SERVICE INFORMATION LETTER

TO: DA20 A-1 Operators	FROM: Certification	CONTROL NO: SIL20A1-001	REVISION: NC
ATTN: All DA20 A-1 Operators	ORIGINATOR: Kety Bussolo	PAGE: 1 of 1	
PHONE NO:	PHONE NO: 519-457-4000 Ext 3139	A/C MODEL: DA20 A-1	A/C S/N:
FAX NO:	FAX NO: 519-457-4031	ATA NO: 61	
DATE OF REQUEST: 22 January 2008	PUBLICATION AFFECTED: LOAP		
TITLE: Service Information Letter for the Mandatory Service Bulletin "Replacement of the propeller gearbox for some Rotax engines type 912/914 (series)"			
REFERENCE: SB-912-056/SB-914-038			
ISSUE: Due to a slightly increased amount of irregularity in the form of material inclusions some isolated problems were detected on the gear box gear set in the field. Such material inclusions in the area of the tooth base can lead to tooth breakage under severe operating conditions. Affected gear sets must be replaced.			
RESOLUTION: Only the following engines may be affected: 912S & 914F The following Mandatory Service Bulletin (attached) affecting specific engines, gear boxes and gear set serial number ranges has been released by Rotax: SB-912-056 / SB-914-038 Replacement of the Propeller Gearbox for some Rotax engine type 912/914 (series). COMPL

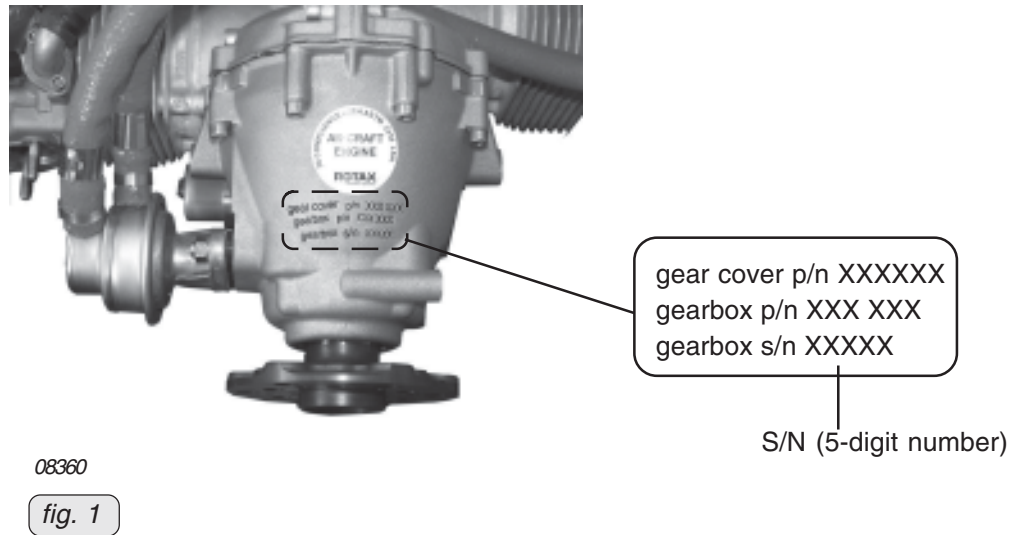
- ◆ **NOTE:** The relevant serial number of the gearbox is visible on the gearbox housing (see fig.1).
